# ***Interactive comment on “Exceptional floods in the Prut basin, Romania, in the context of heavy rains in the summer of 2010” by Gheorghe Romanescu and Cristian Constantin Stoleriu***

**Gheorghe Romanescu and Cristian Constantin Stoleriu**

Received and published: 1 December 2016

Fig. 1.

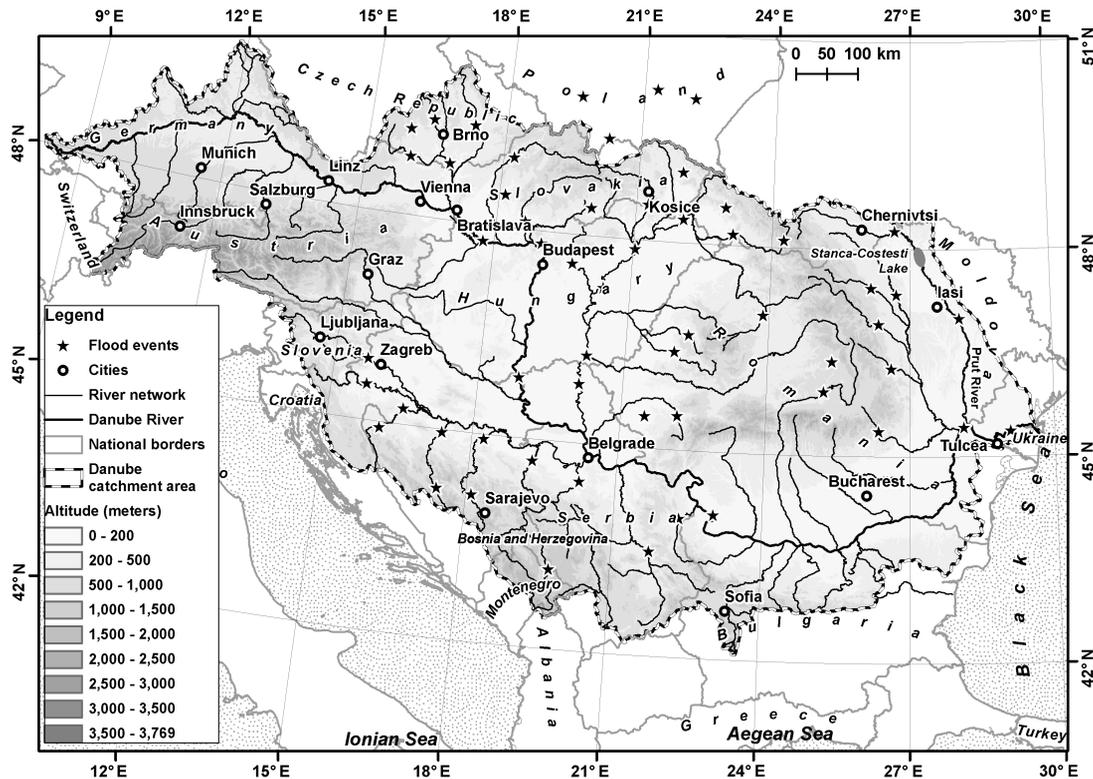
Referee comment 4: Line 61: are the Stanca-Costesti reservoir and the Prut reported in Fig. 1?

Authors' answer4: We modified the Figure 1, in order to appear River Prut, Danube and Stanca-Costesti reservoir.

Fig. 3.

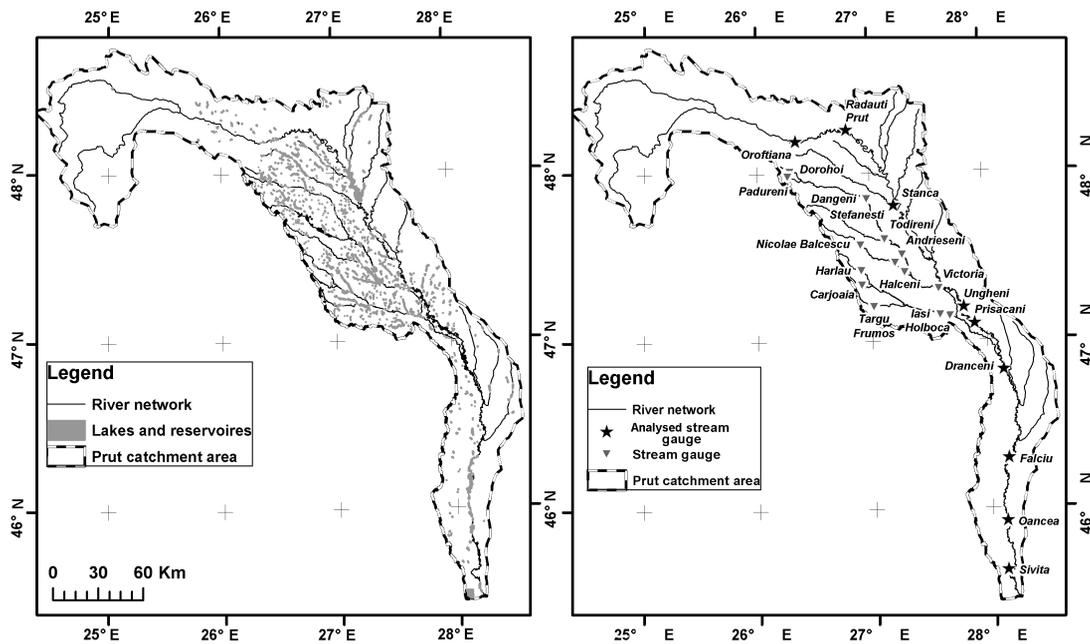
Referee comment 12: Line 168 You need to specify what is registered in each station. What do you mean by "only water levels"? the stations reported in Table 1 should be easily identified in Fig. 3 (by using a different marker) and what is observed (level or discharge should be mentioned. Fig. 5 is not easy to read Line 199 and line 203. What is meant by "floods were recorded"? Do you mean that a flood gauging was operated instead of using the rating curve?

Authors' answer12 : Figure 3 was modified by using different marker. For line 168 "At Oroftiana gauging station, only the water levels data were registered. And for all other gauging stations are registering, in addition to water level, the discharges data." For line 199 and line 203 Floods were registered at the gauging station.

Fig. 6.

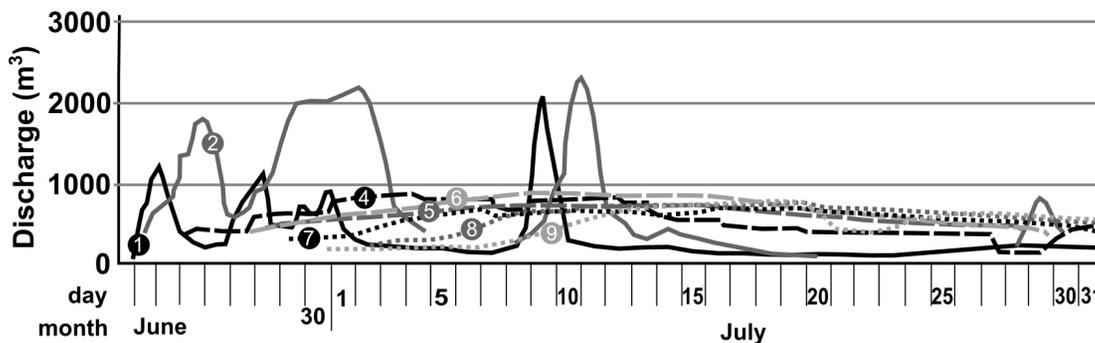
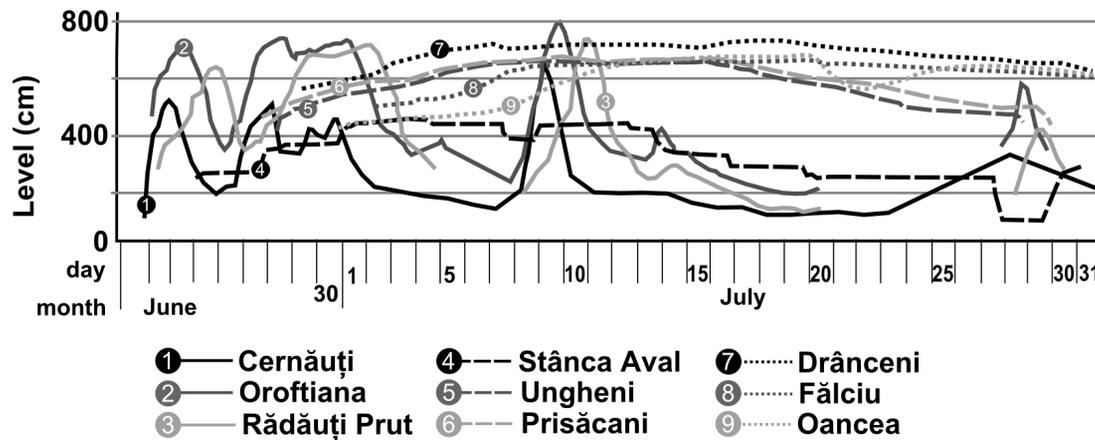
Referee comment 14: Line 243 and elsewhere "Fig. 3 and 6" is not clear. Fig 6 is not easy to read. The peculiarity of Stefanesti(?) station should be mentioned and analyzed in the text. (lines 218 to 221) In all figures, with levels and discharges plts the basin area should be mentioned as well as in lines 310-315.

Authors' answer14 : The figures were modified for a better readability. Stefanesti gaug-
